## Addendum 02

**Project:** CSV Pavillon de la Jeunesse Child Care Addition  
105 High St, Hamilton, ON

**Date:** 12 December 2024

**E-02**

DRAWING TITLE: ELECTRICAL SPECIFICATIONS

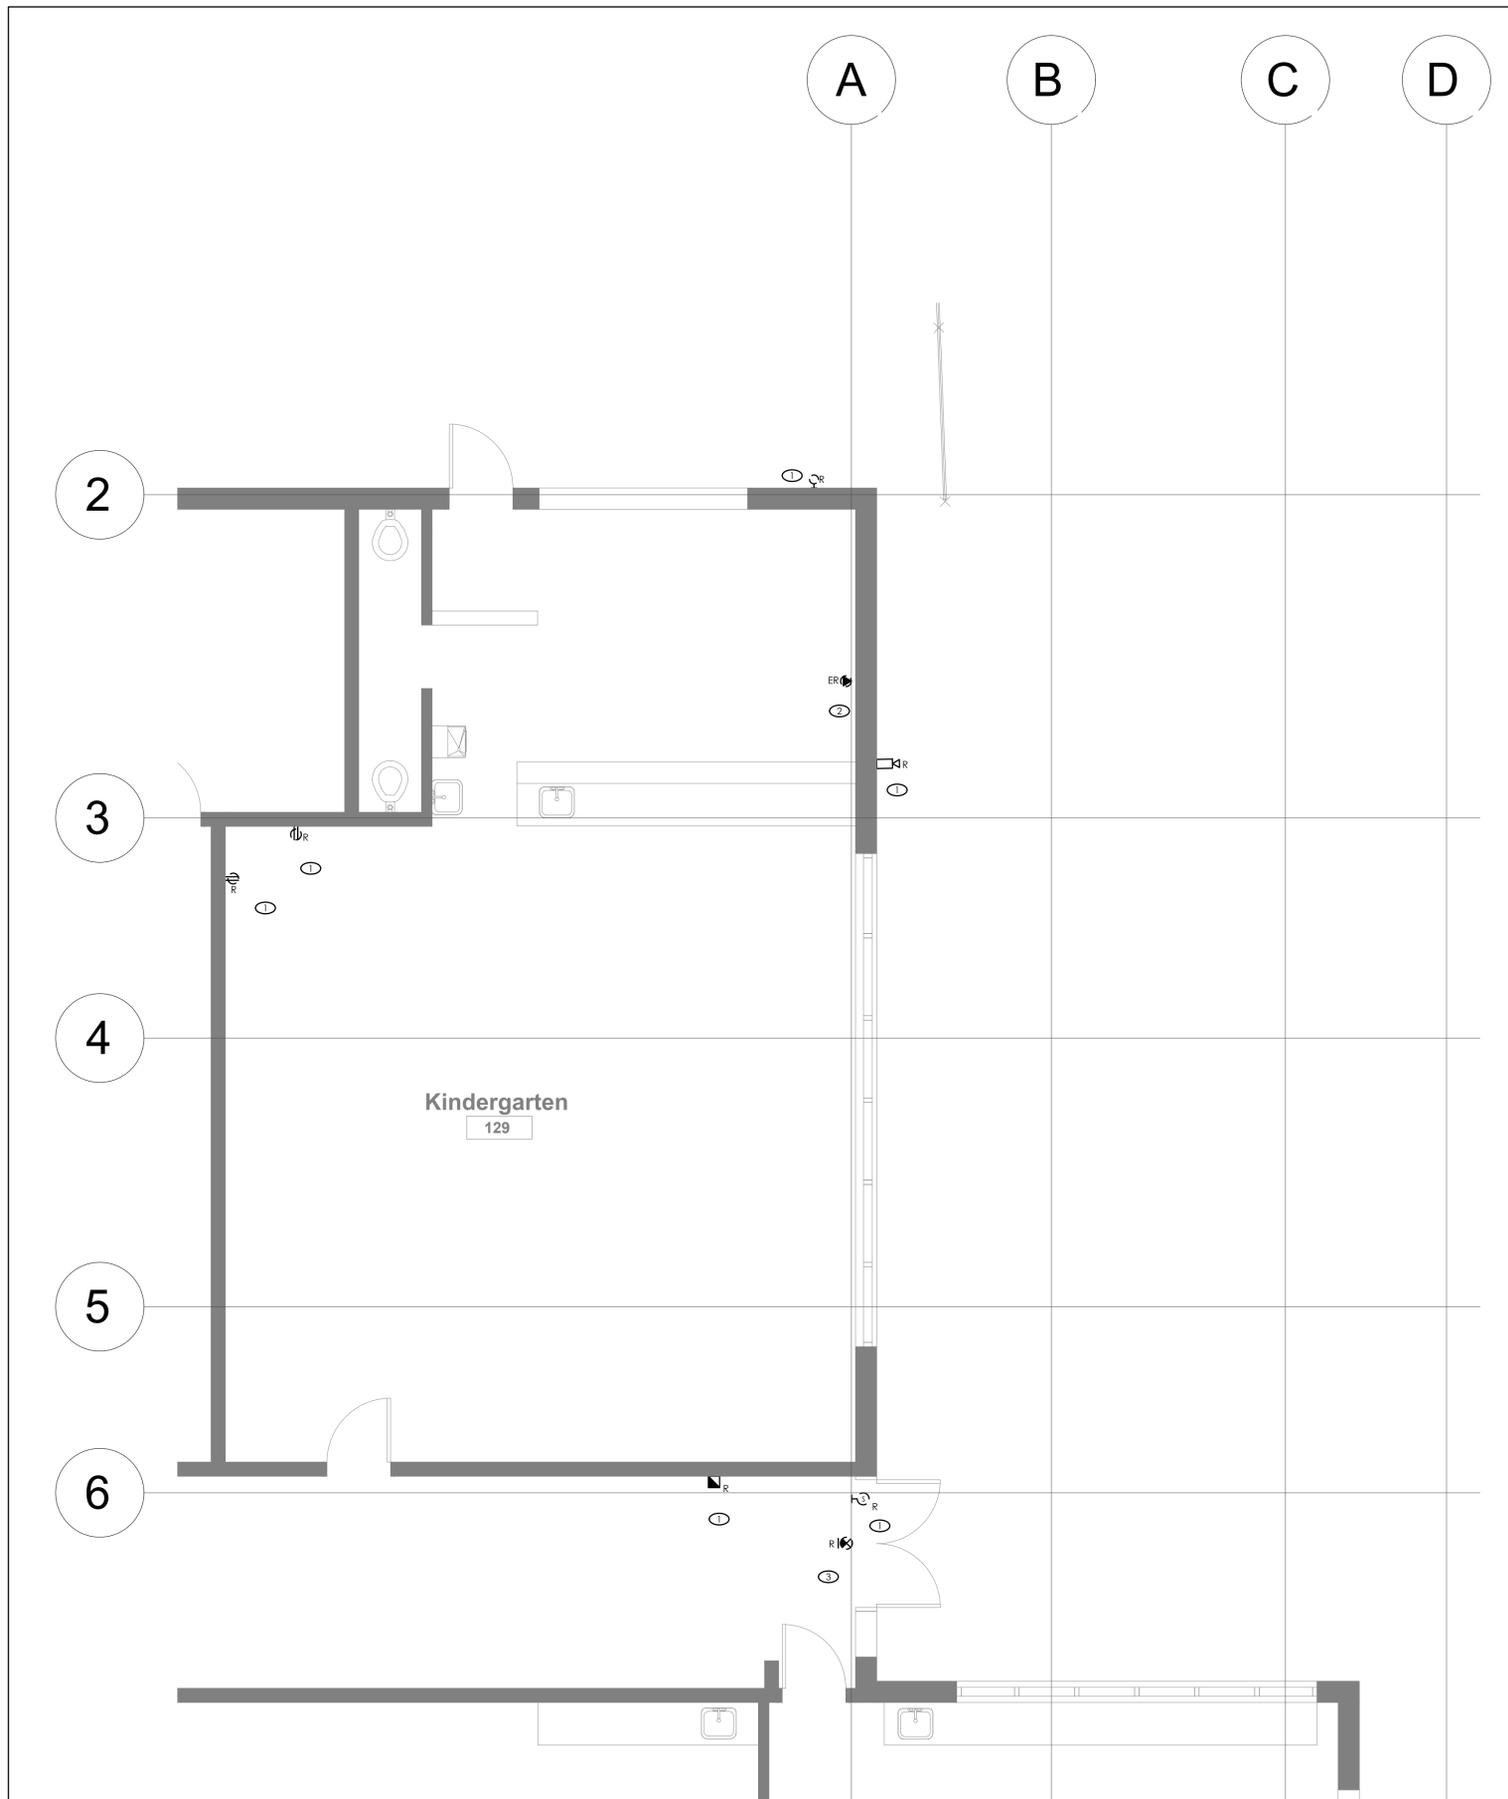
- .1 E0.1 Electrical Specifications
  - Updated specifications to include additional security information
- .2 E0.2 Electrical Specifications
  - Updated specifications to include additional security information
- .3 E1.0 First Floor Power and Lighting Demolition Plan
  - Updated scale in title block
- .4 E2.1 First Floor Proposed Power Plan
  - Added security hardware to door DS06
  - Added ADOs to doors D105A and D105B
  - Updated circuits to accommodate new ADOs
  - Updated scale in title block
- .5 E2.2 Existing Power Plan
  - Updated scale in title block
- .6 E4.0 Electrical Schedules
  - Updated ADO circuits
- .7 E5.0 Electrical Details
  - Added side view and depth to classroom control panel detail

DRAWING TITLE:  
FIRST FLOOR POWER  
PROPOSED PLAN

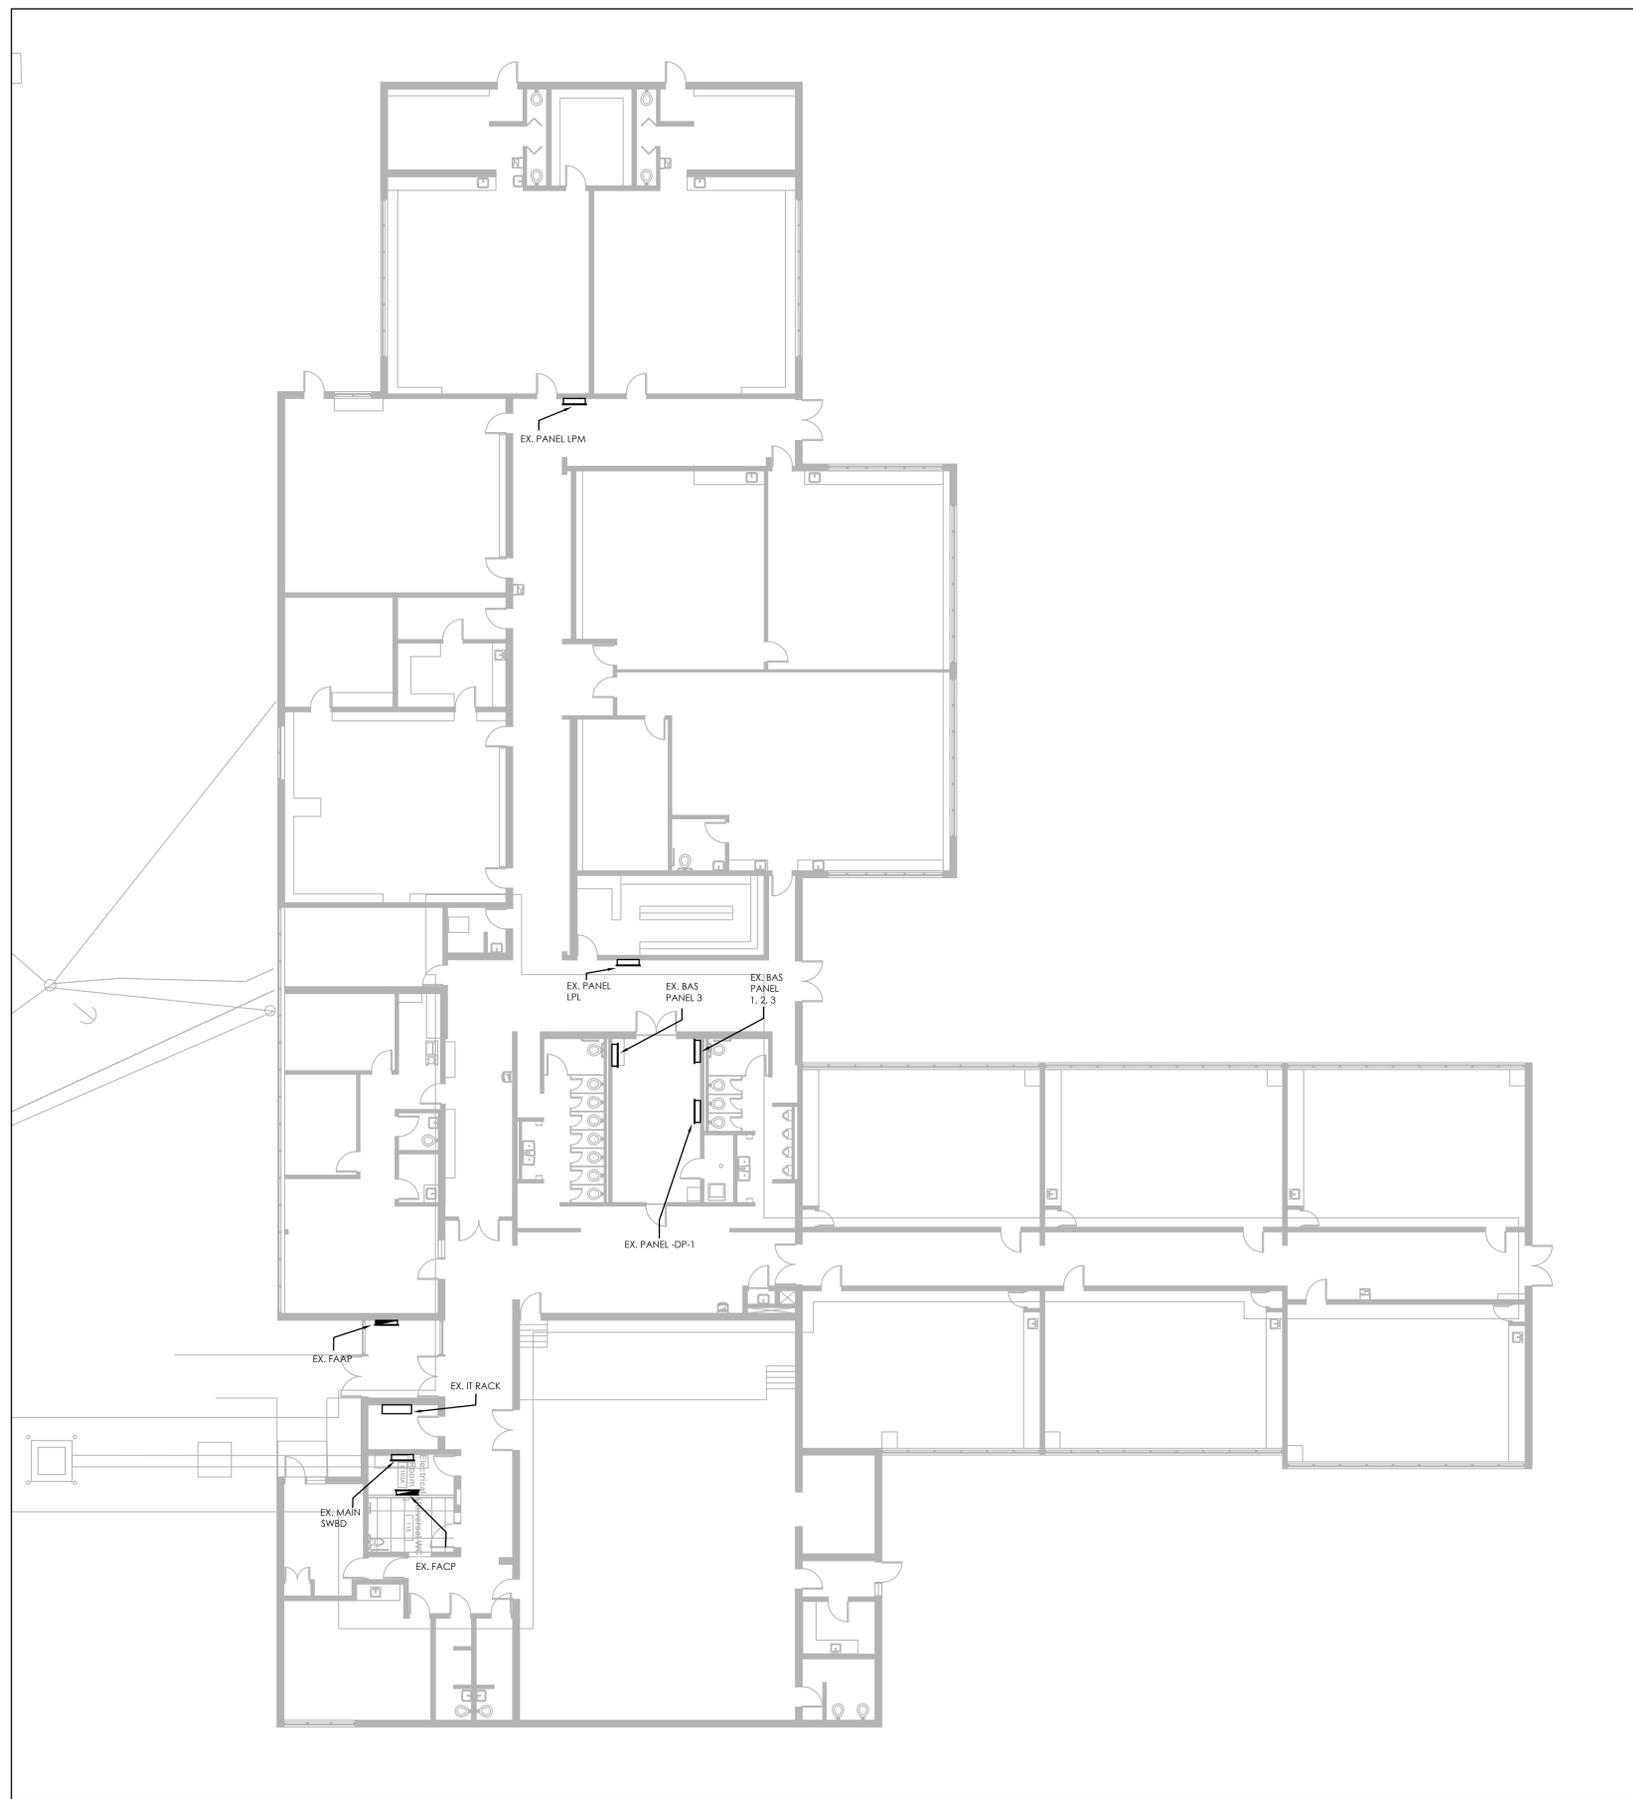
1.06	<b>Question:</b> D105A and D105B require ADOs as per the door schedule and hardware schedule but show nothing on the electrical power plan. Please confirm if these are required. <b>Answer:</b> Yes, power door operators are required at door D105A and D105B. Refer to Electrical Addendum E-02.
